# WATER DISTRIBUTION SYSTEM
to serve
# VIA CHRISTI ST. JOSEPH EMERGENCY DEPT. Ph. 2
3600 E. HARRY
## CITY OF WICHITA, KANSAS
Paul Gunzelman, P.E. City Engineer
2024-030297PPW
54030980

**AS-BUILTS**

VIA CHRISTI ST. JOSEPH EMERGENCY DEPT. Ph. 2

**LINE 1**

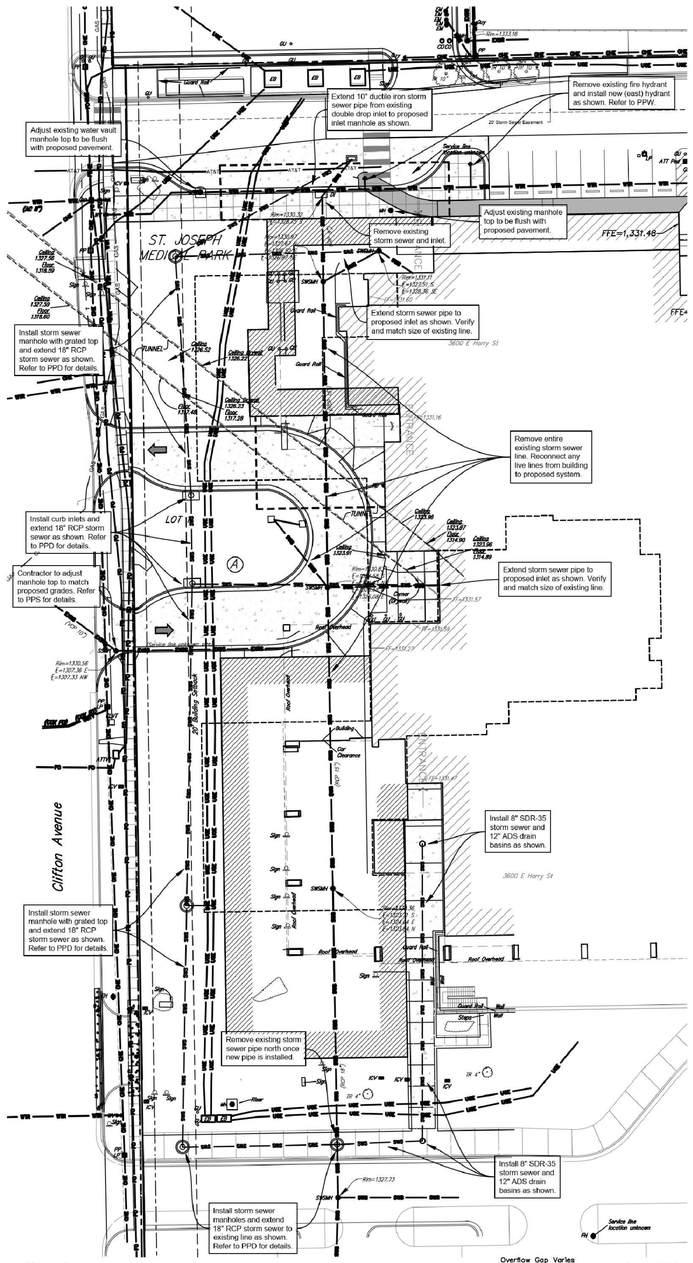
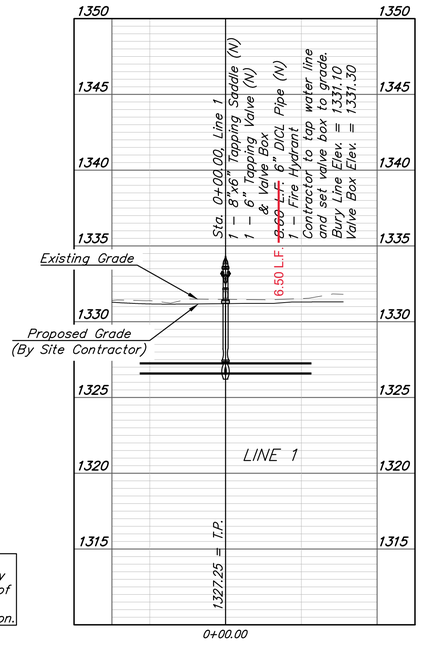
Contractor to verify whether the system is looped. If looped, bring south detector check valve up to City specs.

The original vault was large enough to accommodate the double detector check valve replacement. The existing vault could not be removed and replaced because nearby footing and utilities were in the way. Therefore, Beran Concrete poured a new concrete lid and reused the existing frame and lid components from the old concrete lid. The existing bypass meter and ERT were also reused. While also, chain and padlock were added to secure the new double detector assembly. Installment was confirmed by the GC (McCownGordon).

From RP:
52.00' North & 166.00' East Tapping Sleeve
53.00' North & 166.00' East FH/Tap Valve
60.50' North & 166.00' East Fire Hydrant
